REFUSAL OF PLANNING PERMISSION

Site location: 51 Weymouth Road Hayes

Description:
Erection of a two-storey side extension and single-storey rear extension.

Item No. **Report of the Head of Development Management and Building Control**

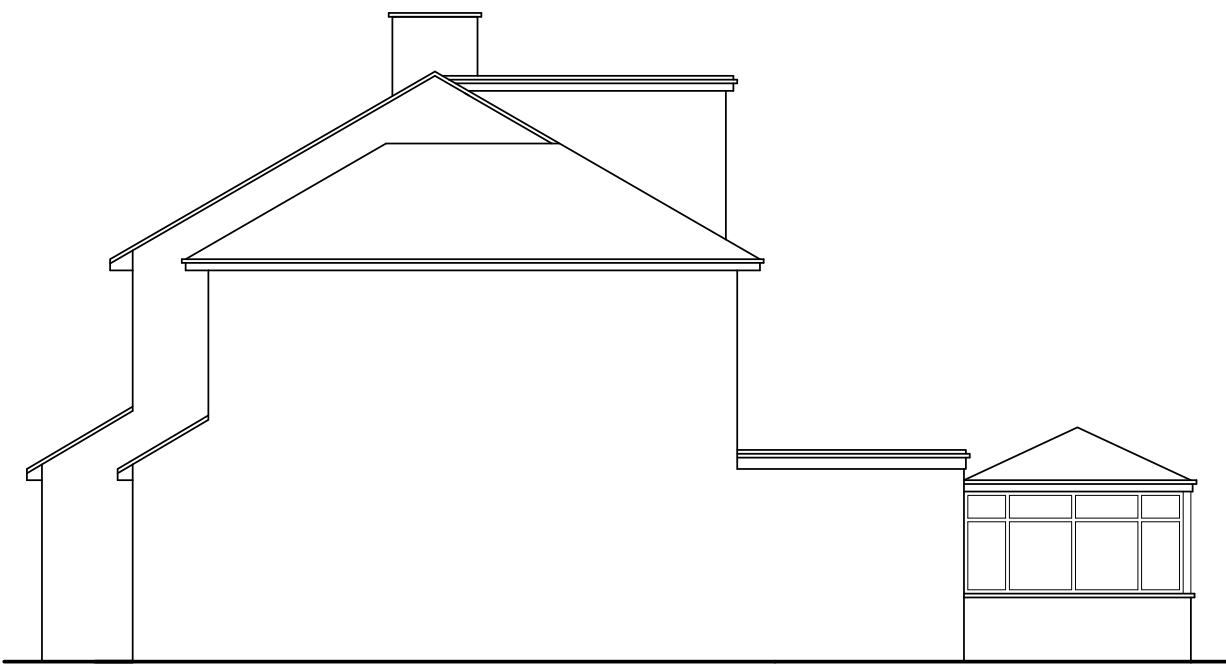
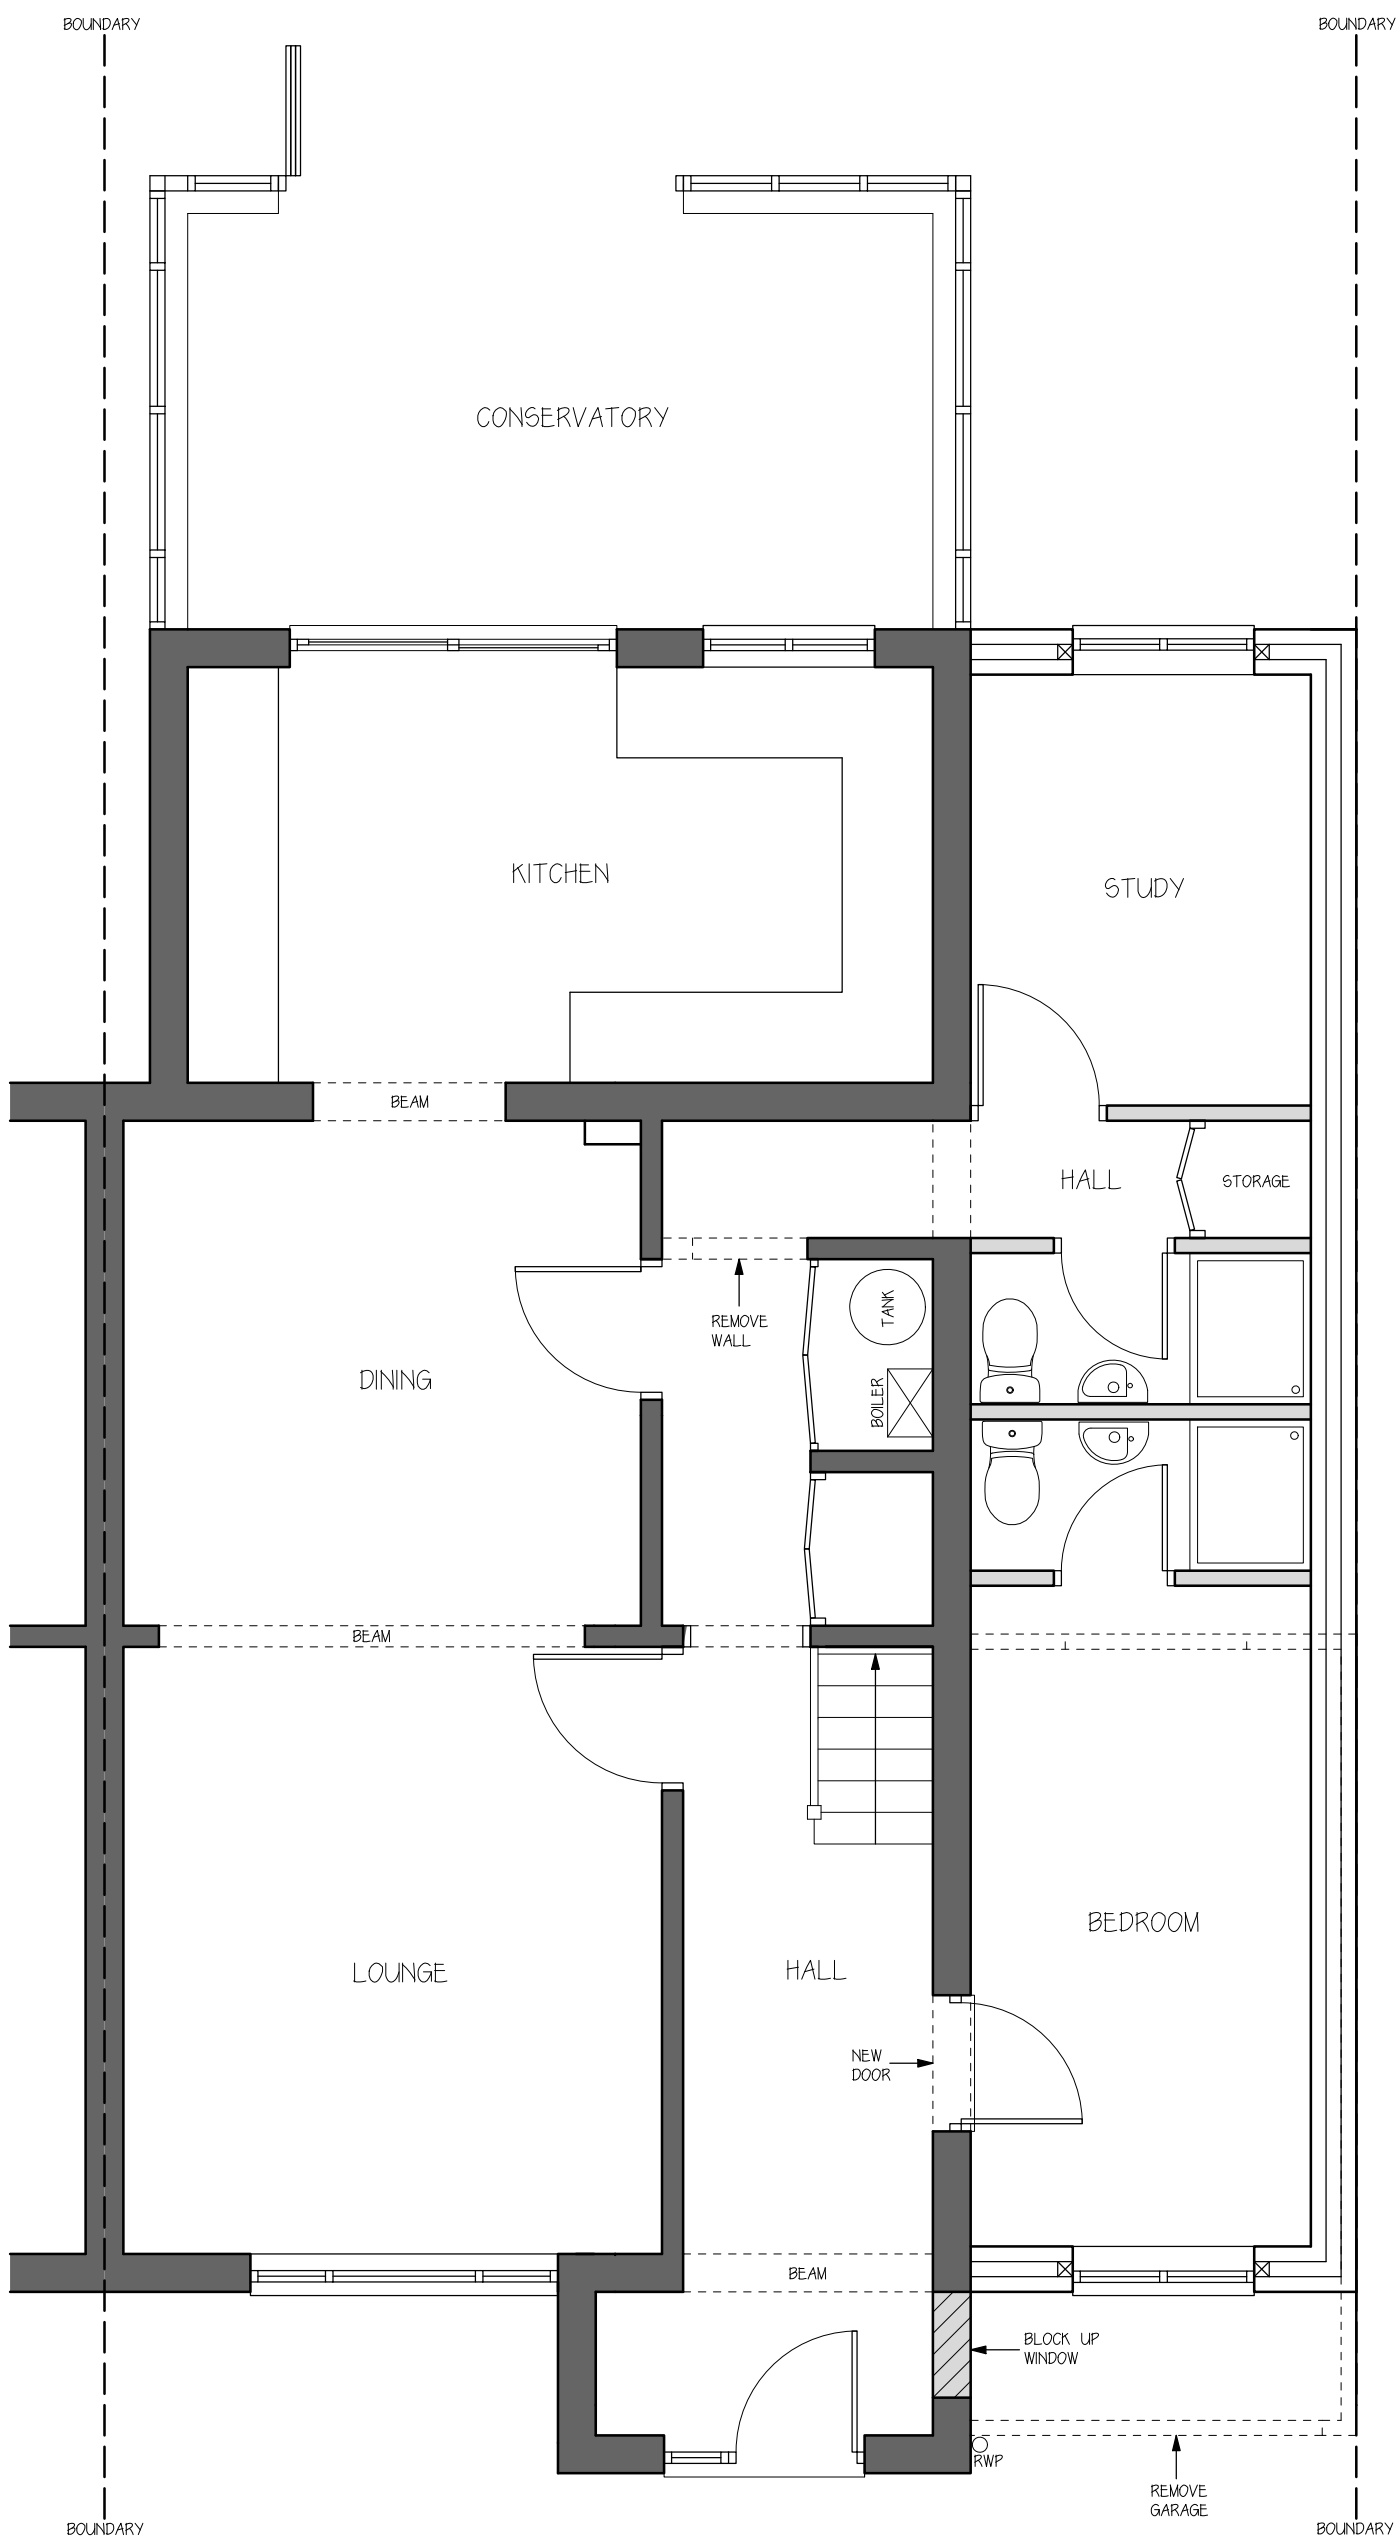
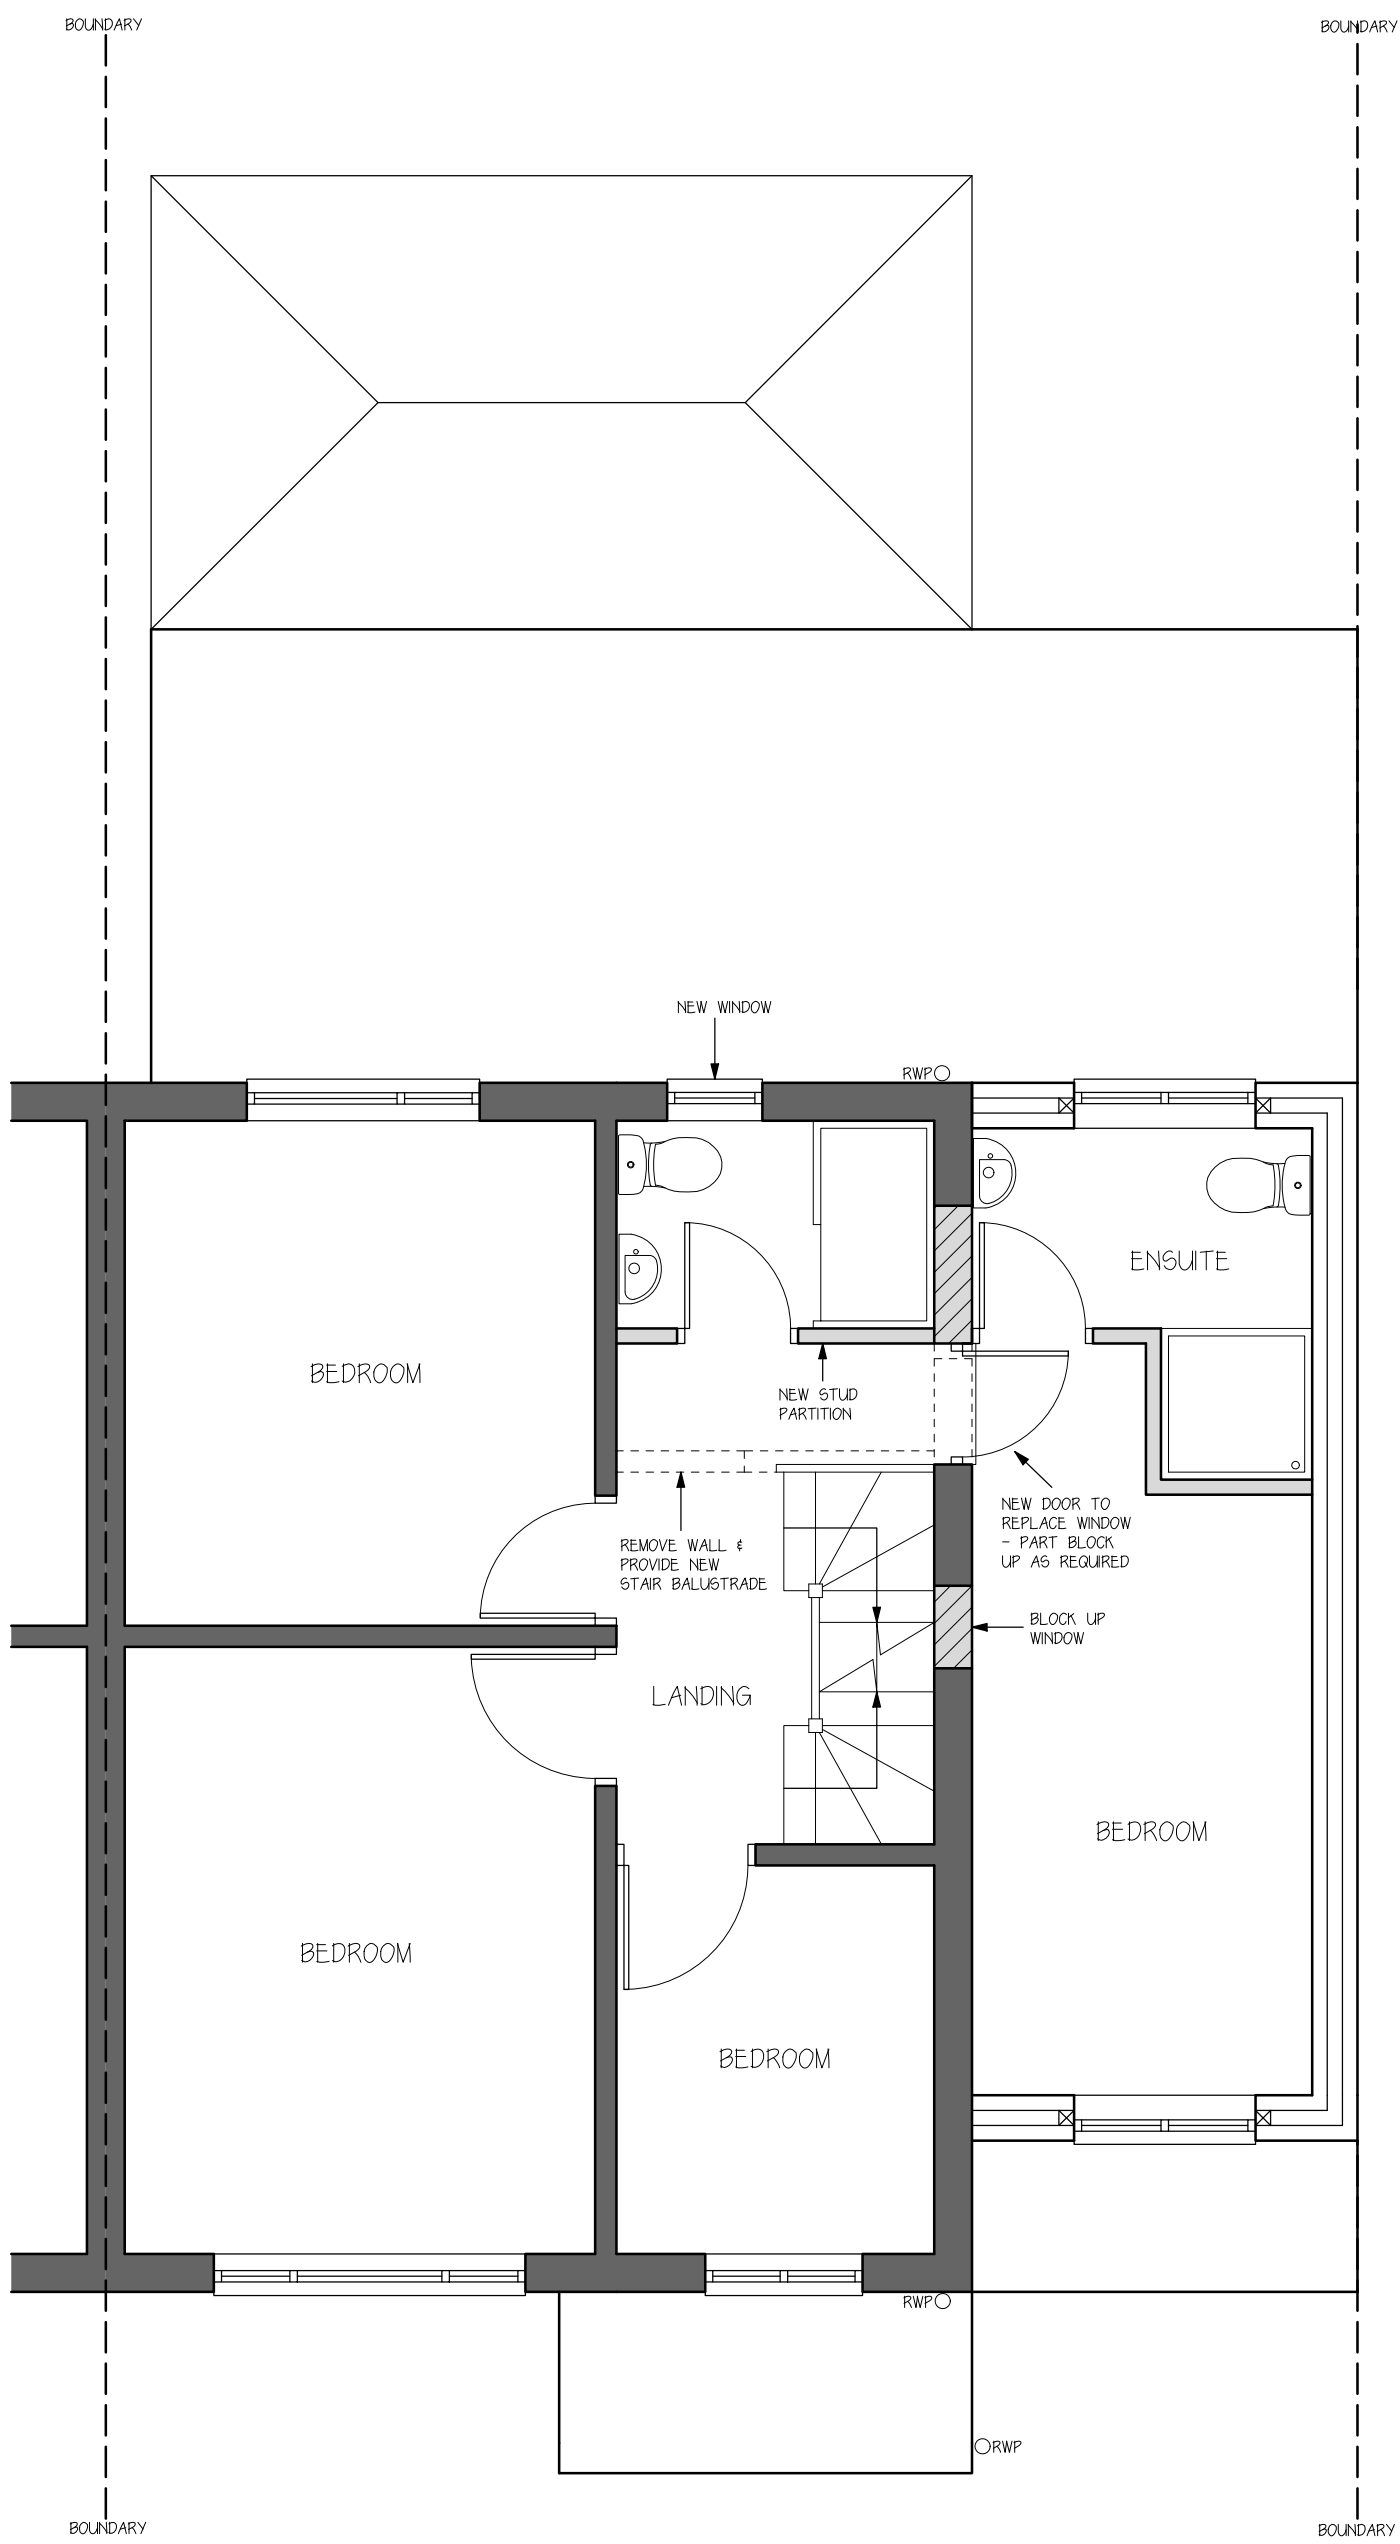
The proposal would create a two-storey side extension with a single-storey rear extension. The scheme differs from that which was dismissed at appeal (Appeal Ref: APP/R5510/D/23/3333501) in that the first floor would be set back 1 metre (compared to 500mm set back of the dismissed proposal), and the roof would be hipped (compared to the gabled dismissed proposal).

The two-storey side extension would be less than half the width of the original dwelling, with the ground floor following the building line of the front elevation and the first floor being set back 1 metre. The first-floor side extension would have a hipped roof form, with its ridge set down approximately 0.95 metres from the existing roof's ridge line. The side extension would run along the side boundary.

The current proposal differs from that which was considered at appeal in that the extension would be set under a hipped roof, set down from the main ridge. The hip could be considered to add some balance to this semi-detached pair. However, it would be at odds with the gabled roof form of the host dwelling. The Inspector's comments with respect to the character of the area and two-storey side extension are relevant in this case. The Inspector advises:

Officers acknowledge that attempts have been made to address the previous concerns about symmetry but consider that the proposal fails to overcome the concerns relating to visual amenities. The proposed two-storey side extension, by virtue of its size, scale, bulk, and design, including the awkward juxtaposition of the proposed hipped roof with the existing roof works, would fail to harmonise with the architectural composition of the host dwelling and would be detrimental to the character, appearance, and visual amenities of the street scene and the surrounding area. The proposal is, therefore, contrary to Policy BE1 of the Hillingdon Local Plan: Part One - Strategic Policies (2012) and Policies DMHB 11, DMHB 12, and DMHD 1 of the Hillingdon Local Plan: Part Two - Development Management Policies (2020).

Furthermore, the two-storey side extension, by virtue of its proximity to the boundary, would result in the harmful loss of a first-floor gap, which would appear cramped and incongruous with the character and appearance of the wider street scene. As a result, the development as a whole would fail to comply with Policies DMHD1 and DMHB 11 of the Hillingdon Local Plan: Part Two - Development Management Policies (2020).

The proposed two-storey side element would be set up against the boundary with No 53 Weymouth Road. No 53 Weymouth Road has two upper windows on their side elevation facing the application site. Whilst one appears to be obscured and servicing a bathroom, the other window upper floor side-facing would be impacted through the bulk and massing of the proposal in such close proximity. However, given that this window would rely on 'borrowed light' from across the application site, it is not considered, on balance, that any amenity harms would be sufficient to warrant refusal. It is noted that there have been no objections.
